November 5 1970

**KINGSTON STEAM PLANT - ANNUAL AIR FORD DUNE INSPECTION**

**KINGSTON STEAM PLANT - ANNUAL ASH POND DIKE INSPECTION**

On the attached print of 10N400 the different areas are designated.

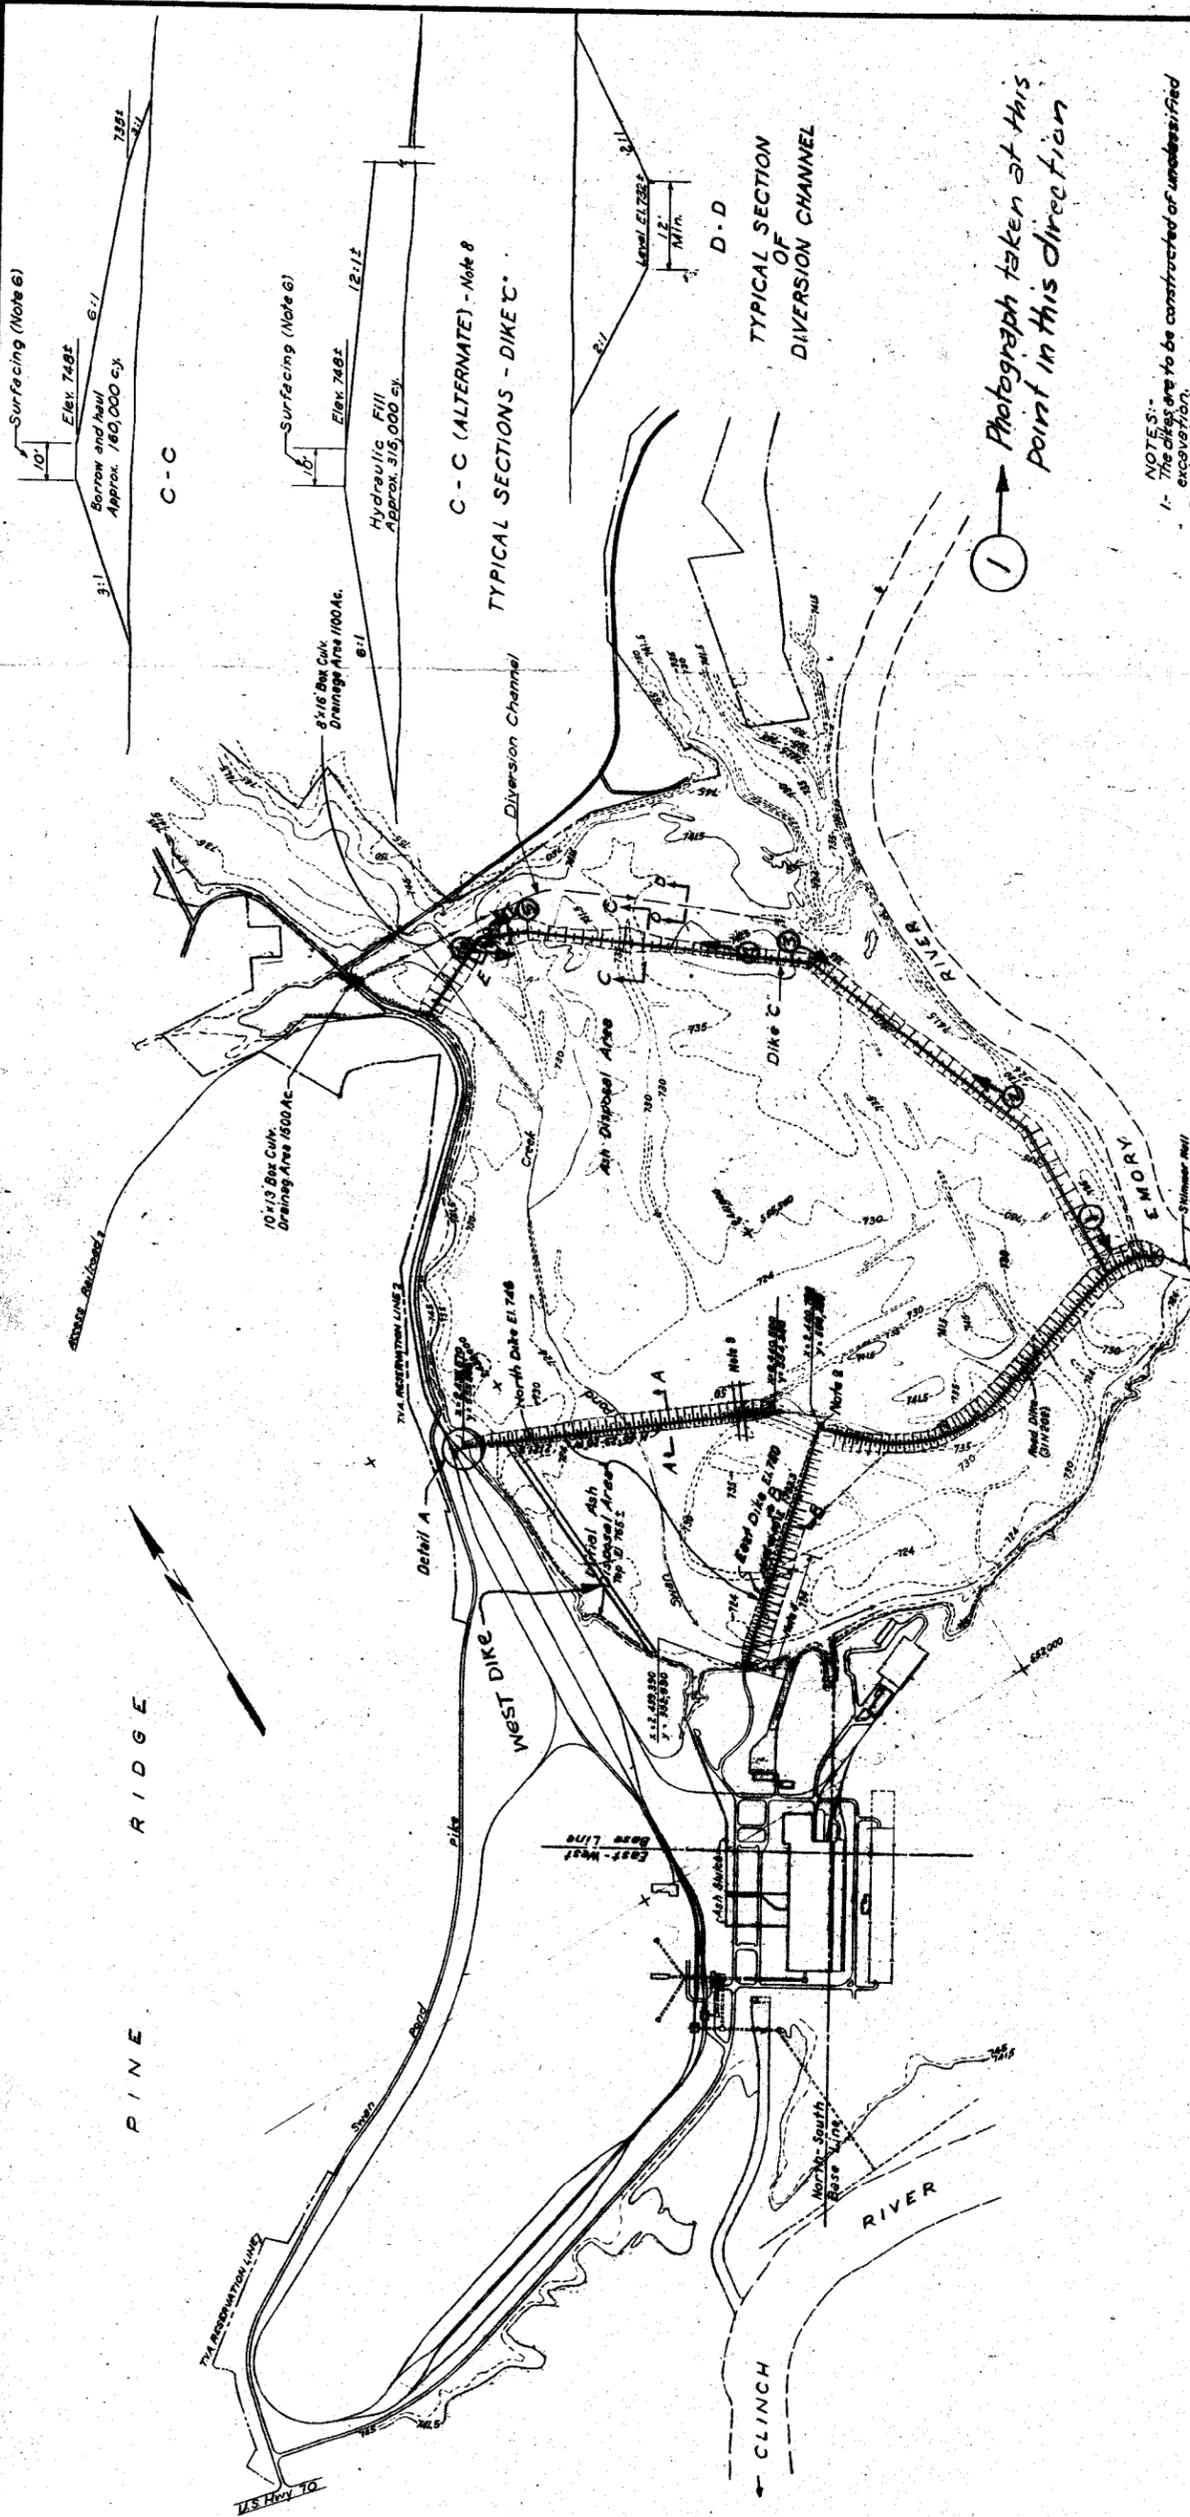
In general, the dikes are in good shape, and there appears to be no stability problem. The original dikes were constructed of earth. The dikes around the initial ash area were raised with ash. In the last year a great deal of work has been done on dike C and the road dike. These two dikes are being raised with earth and ash.

1. Continue grassing the earth slopes.
2. Keep logs and trash removed from the outside slope of dike C.
3. Raise dikes, with earth and ash, as required to maintain 4-foot freeboard in the pond, keeping the top of dike smooth and sloped to the inside. The top of the original dikes shall be left as a berm and the dikes raised with slopes of 2:1 on the inside and 3:1 on the outside with 16-foot top width. The maximum height of each lift shall not exceed 10 feet before providing a berm.
